MEMORANDUM

Travilah Fire Station #32

MR 2010721

Preliminary Forest Conservation Plan

Figure 2: On-site Afforestation Areas

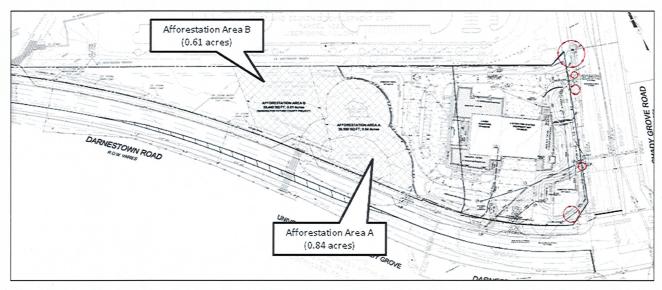
The applicants are proposing to meet the forest planting requirements by planting 1.45 acres of forest onsite labeled as afforestation areas A and B in figure 2. The applicant proposes to use the 0.61 acres of planting from afforestation area B as forest conservation bank credits for future County projects. All forest plantings and stream/environmental buffers must be protected by a Category I conservation easement.

for the construction of sediment and erosion control structures." Since all sediment and erosion control structures are being constructed outside of the proposed afforestation areas, it is recommended that all plantings be completed within the first growing season after the issuance by DPS of a grading permit.

- 1. Submission and approval of a final forest conservation plan prior to any land disturbing activities.
- 2. Applicant must record a category I conservation easement over all forest plantings and stream environmental buffers prior to any land disturbing activities.
- 3. All reforestation plantings must be completed within the first planting season after issuance of the first sediment and erosion control permit.
- 4. Approval of the forest conservation plan is contingent upon the successful abandonment of the Right-of-Way.
